Service Bulletin

Bulletin No.: 20-NA-175

Subject: Vertical Misalignment Between Cab and Pickup Box on Driver Side of Vehicle

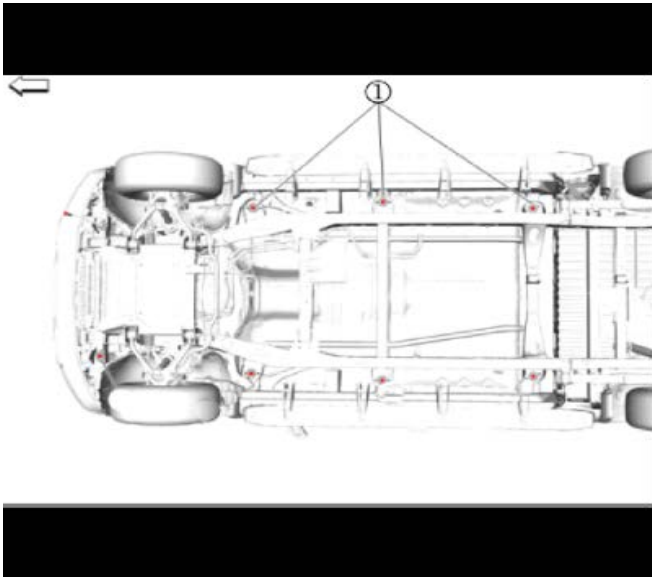
Involved Region or Country	North America, Middle East, Israel, Palestine, Chile, Paraguay and Thailand.		
Additional Options	Crew Cab and Extended Cab Models ONLY		
Condition	 <p>5645798</p> <p>Some customers may comment on noticing anywhere from 2 –10 mm (0.08 – 0.4 in.) vertical misalignment of the body feature line between the cab and the pickup box, on the driver's side of vehicle.</p>		
Cause	The cause of the condition may be pickup box structure variation.		
Correction	Realign the left side of the cab and install shim washers, following the steps in the Service Procedure below.

5645800

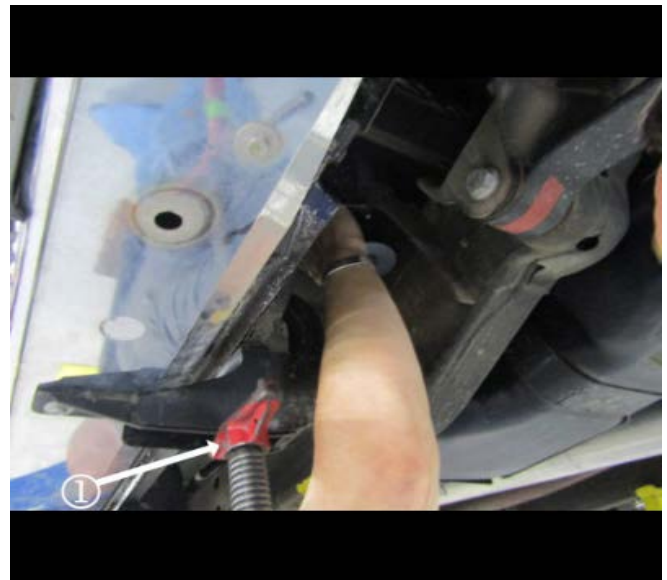
3. Remove the 3 left side body mount bolts and washers (1).

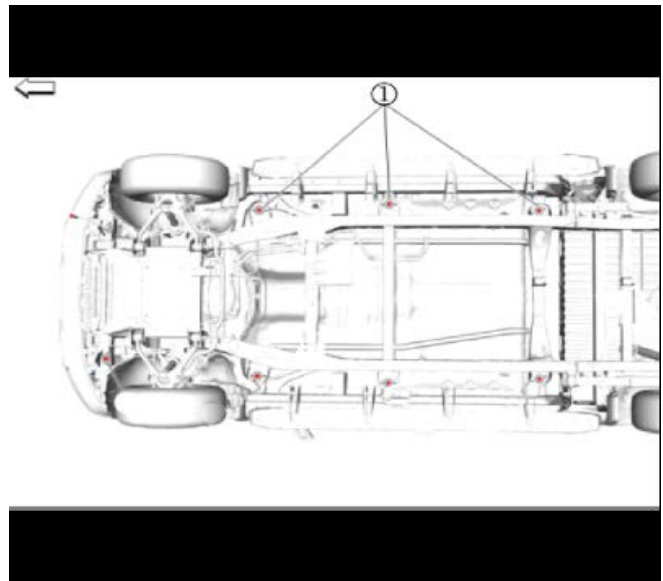
4. Using a jack stand (1), raise the cab high enough to achieve enough clearance to install the shim washers between the body of the truck and the top of each body mount.

5. Install a combination of thick (1) and thin (2) shim washers to each body mount location, following the suggested stack-ups below. The rear most location will have the thickest washer stack-up, and the stack-ups will gradually reduce, going forward.

- 5.1. Install 1 thick, and 2 thin washers, to the rearward most body mount location, and partially thread the bolt.

- 5.2. Install 2 thin washers, to the middle body mount location, and partially thread the bolt.
- 5.3. Install 1 thin washer, to the forward most body mount location, and partially thread the bolt.
6. Remove the jack stand from the cab.
